PLANNING AND ZONING CASE CHECKLIST

P&Z CASE # SP2019-047 P&Z DATE 12/30/19 ^{PZ} CC DATE 01/14/2020 APPROVED/DENIED
ARCHITECTURAL REVIEW BOARD DATE _____ HPAB DATE _____ PARK BOARD DATE _____

Project Number: SP2019-047
Project Name: 2055 KRISTY LANE
Project Type: SITE PLAN
Applicant Name: JEFF CARROLL
Owner Name: BRAD BACON
Project Description:

SUBJECT: SP2019-047; *Site Plan for Lt 1-M, Bodin Industrial Tract*

1 LANDSCAPE PLAN
SCALE: 1:30

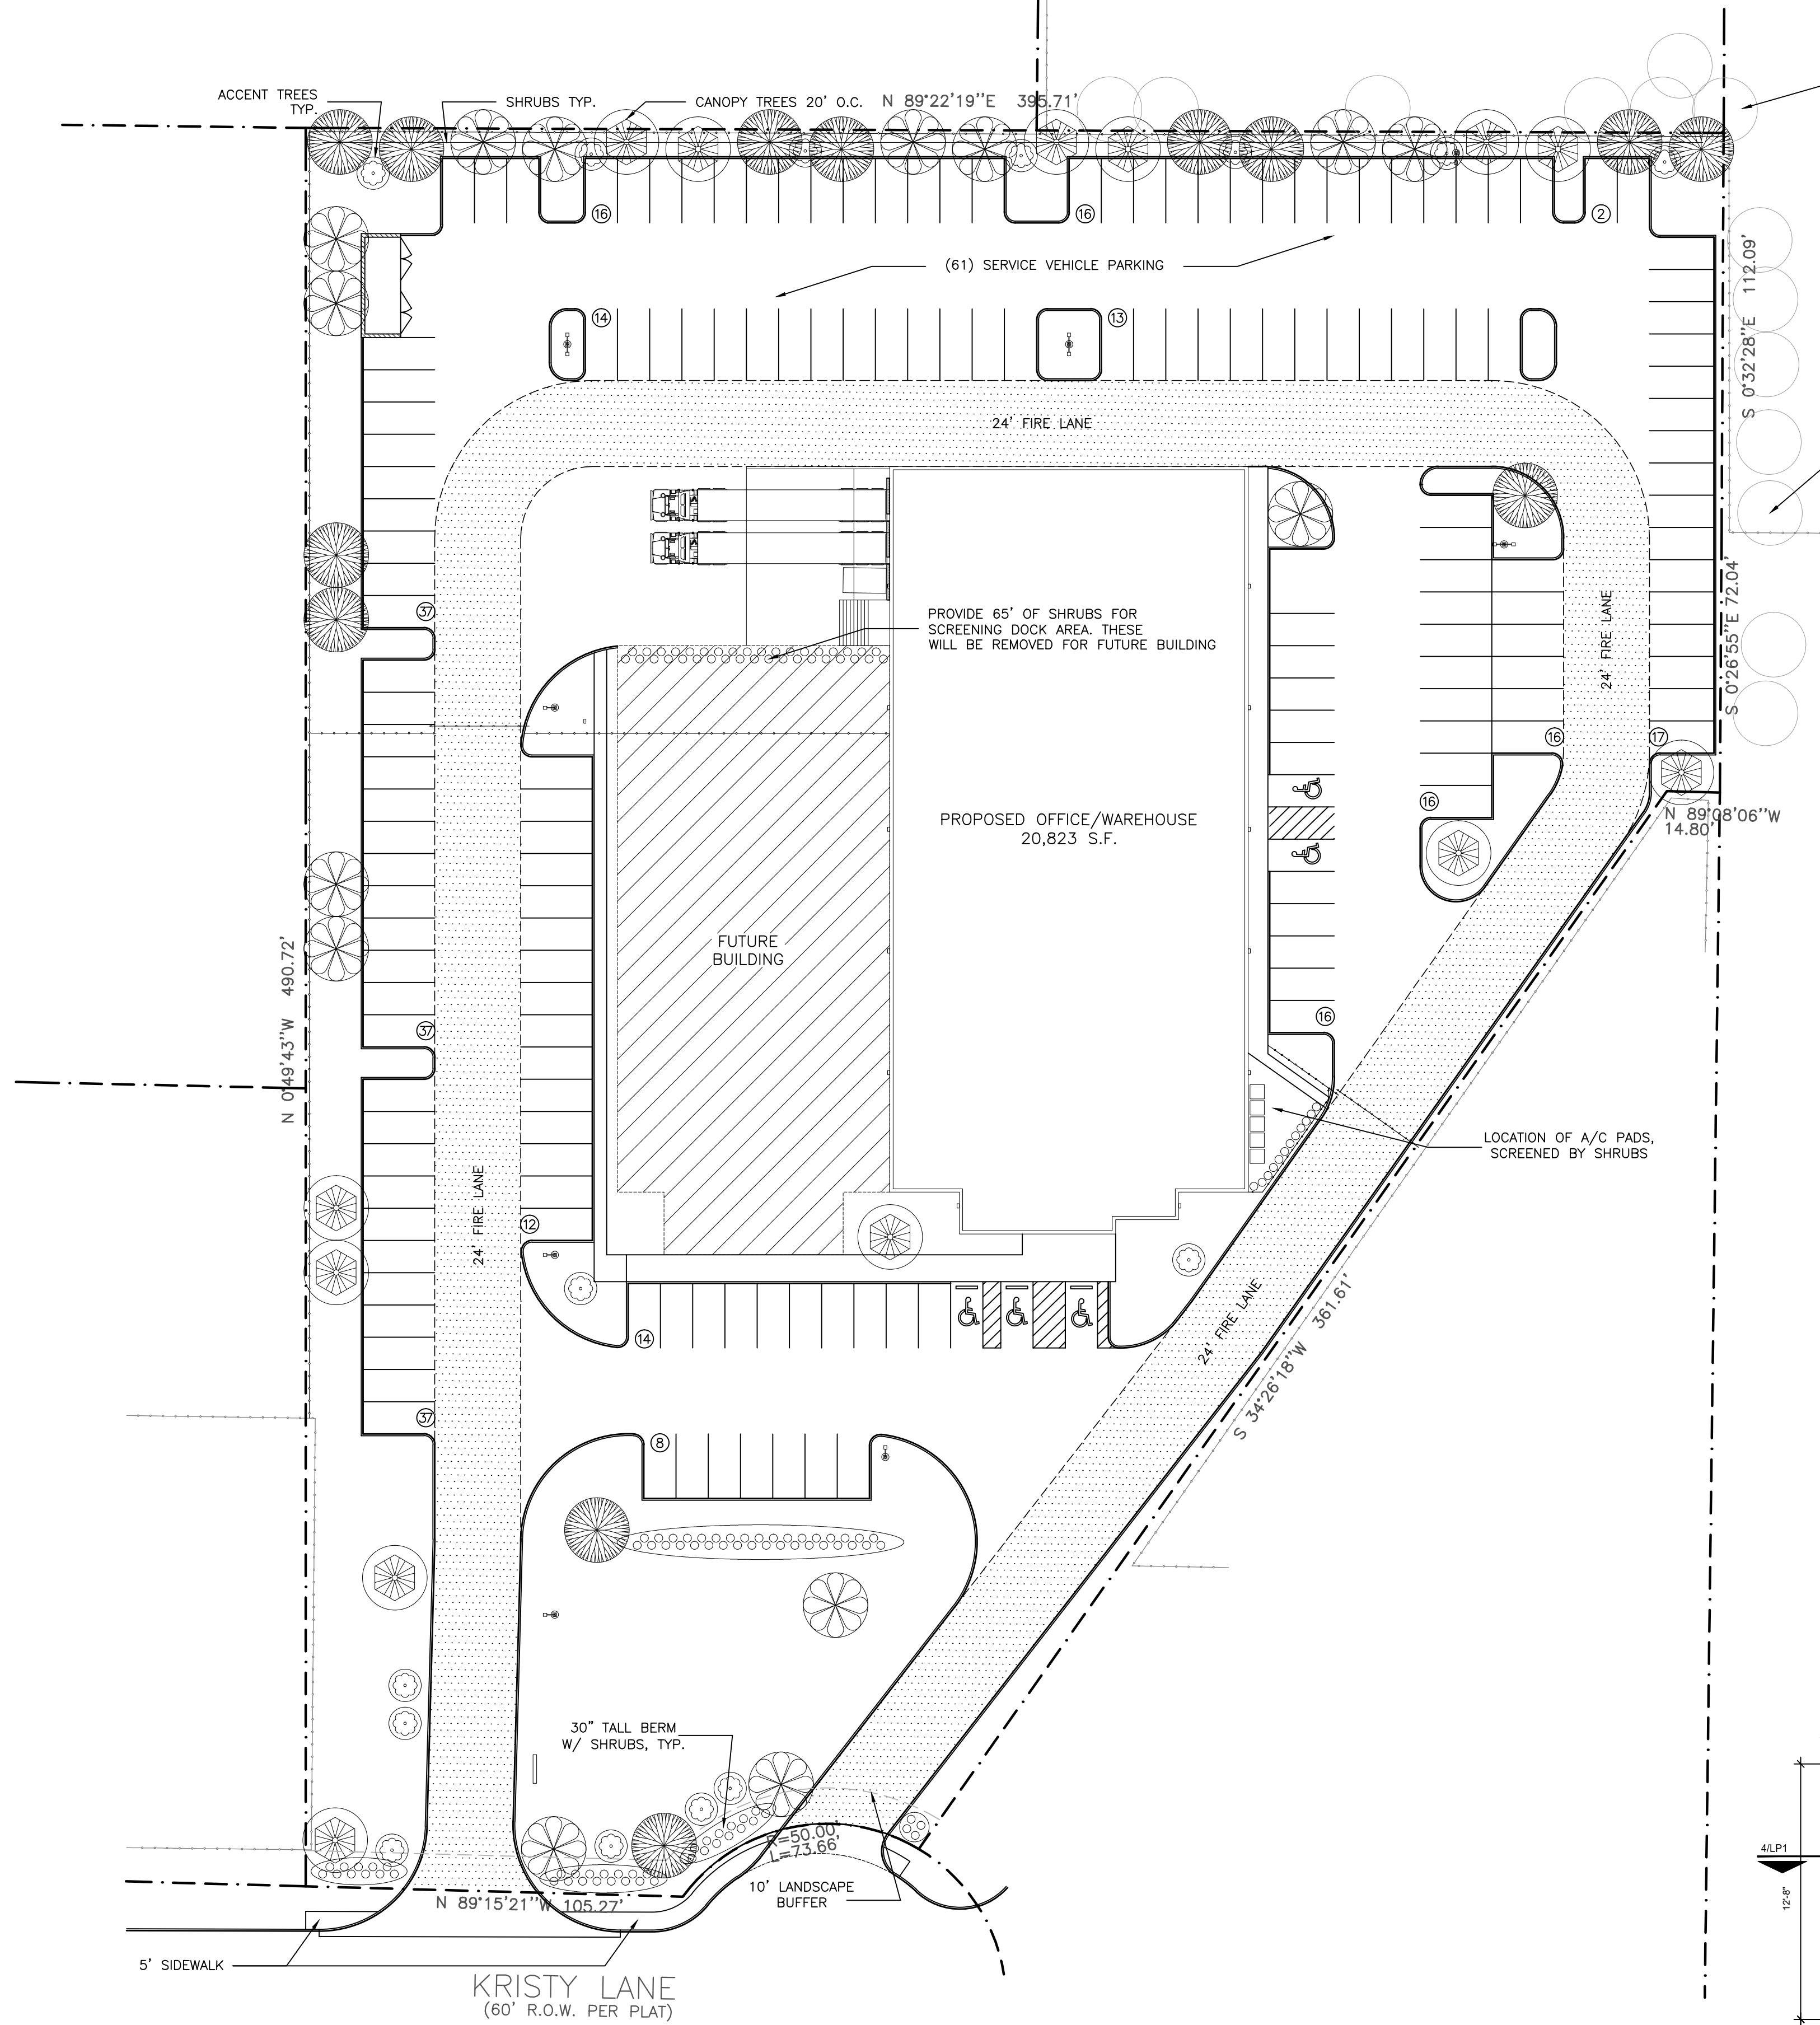
- 7) Landscape Plan. Please make the following changes to the landscape plan;
 - a. Provide visibility triangles for all driveway intersections and public streets. (Subsection 1.08(B), Art. V, UDC).

- b. Provide screening of loading dock area and outside storage areas. (Subsection. 5.02(A), Art. VIII, UDC) Refer to mark-up provided on 01.10.2020.

3 DUMPSTER ENCLOSURE ELEVATION
SCALE: 3/16" = 1'-0"

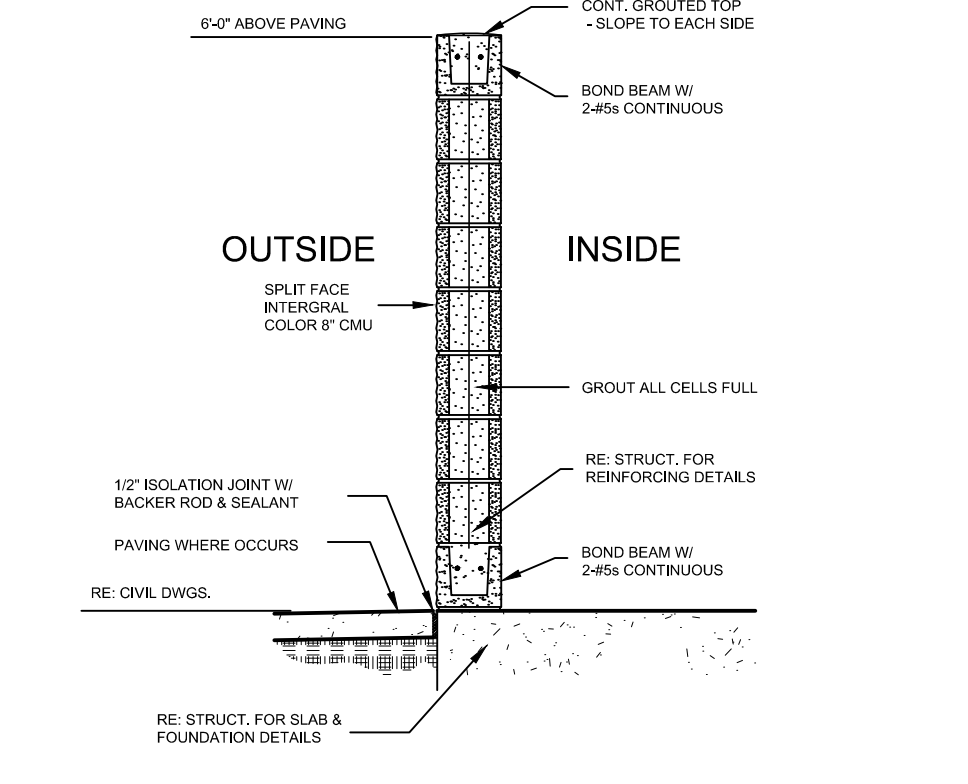
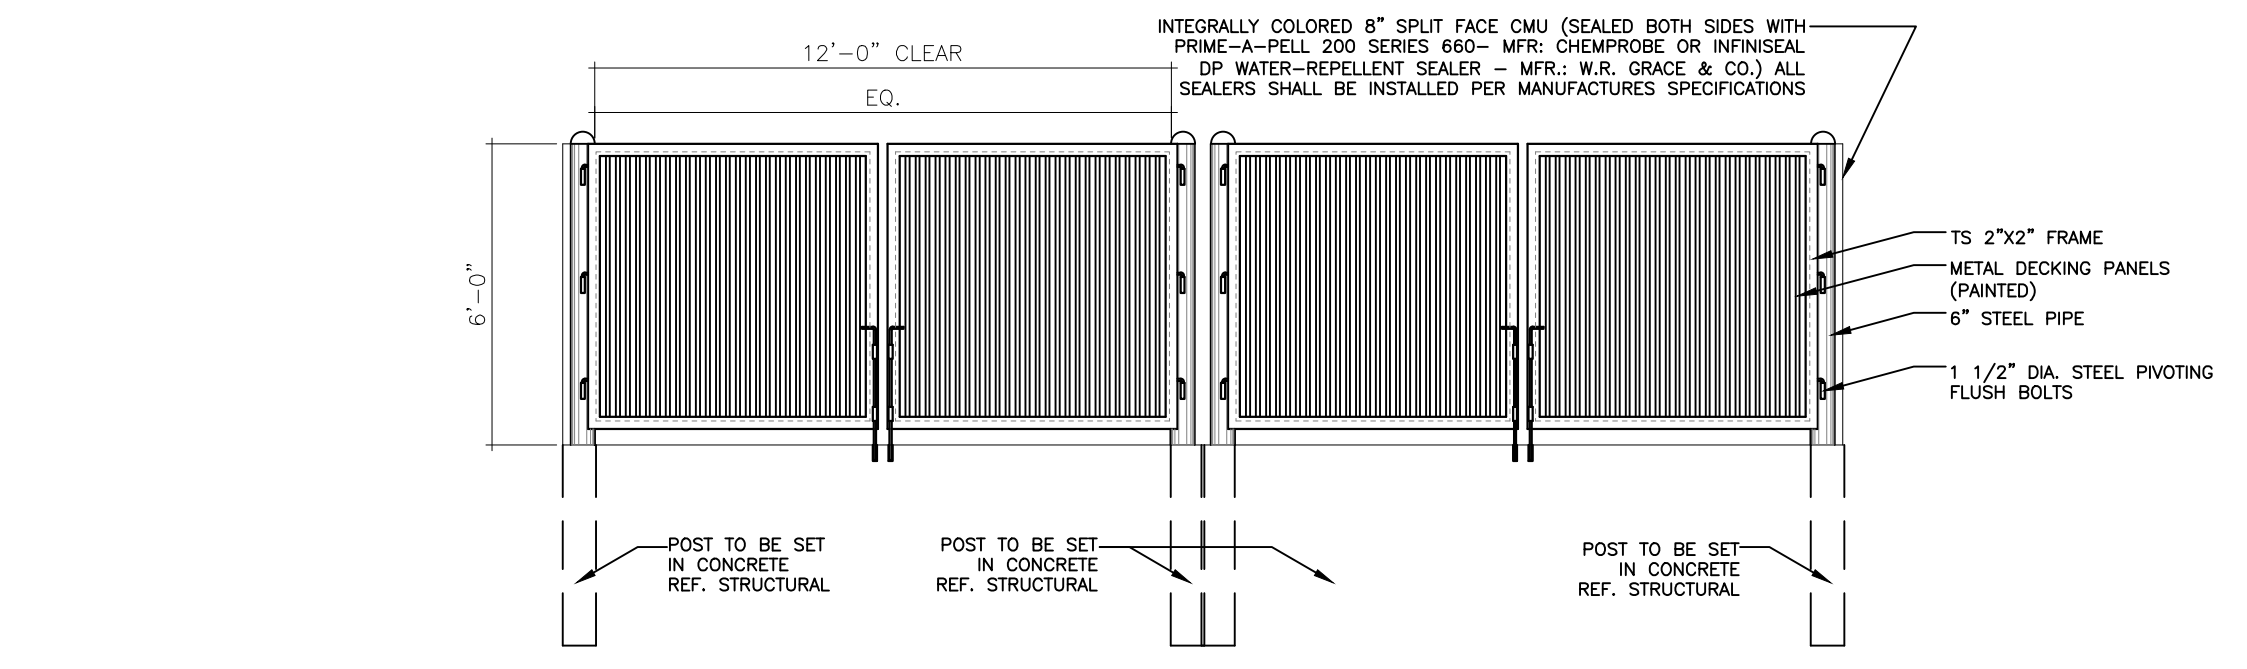
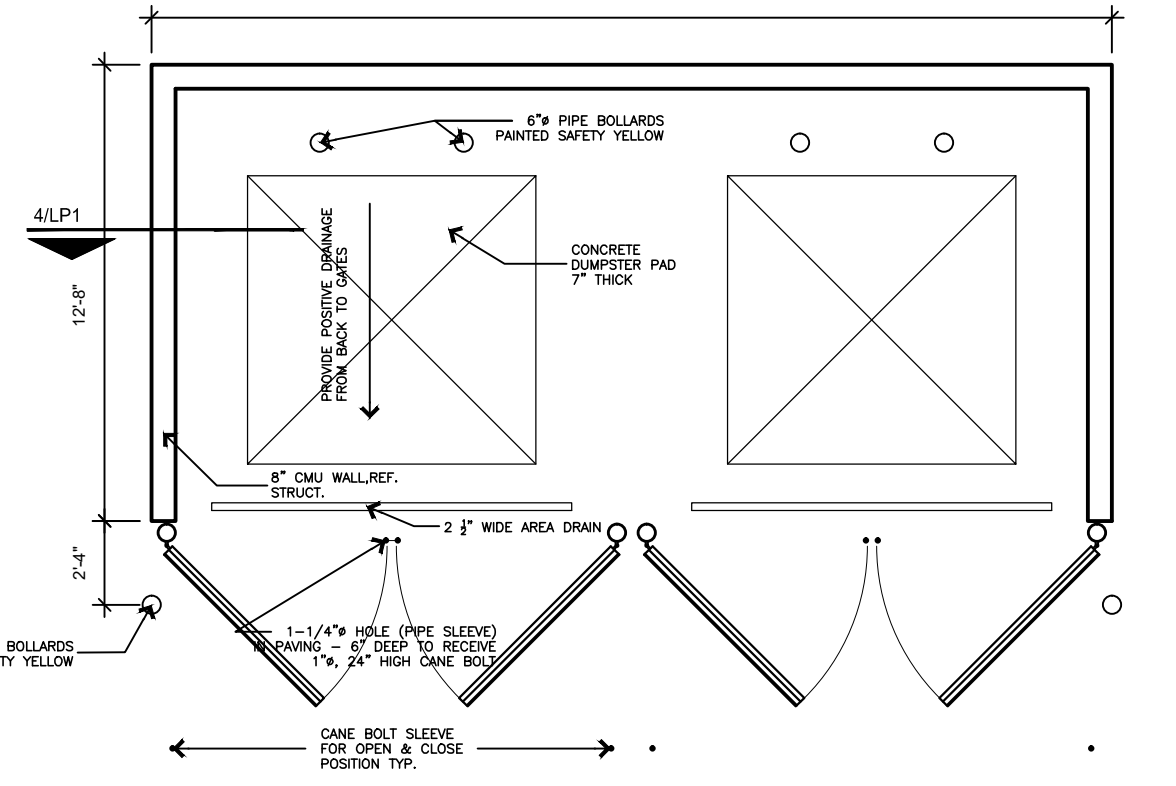
- 2) Dumpster Enclosure. The proposed location of the dumpster enclosure faces a public street. *Exception Required. (Sec. 1.05.3, Art. V, UDC)*.
- 3) Primary Materials. The proposed building is required to be constructed of 90% stone, brick, glass curtain wall, glass block, tile, and custom Concrete Masonry Units (CMU). The applicant is proposing a building comprised primarily of metal. *Variance Required. (Subsection 6.02(C)(1)(a), Art. V, UDC)*
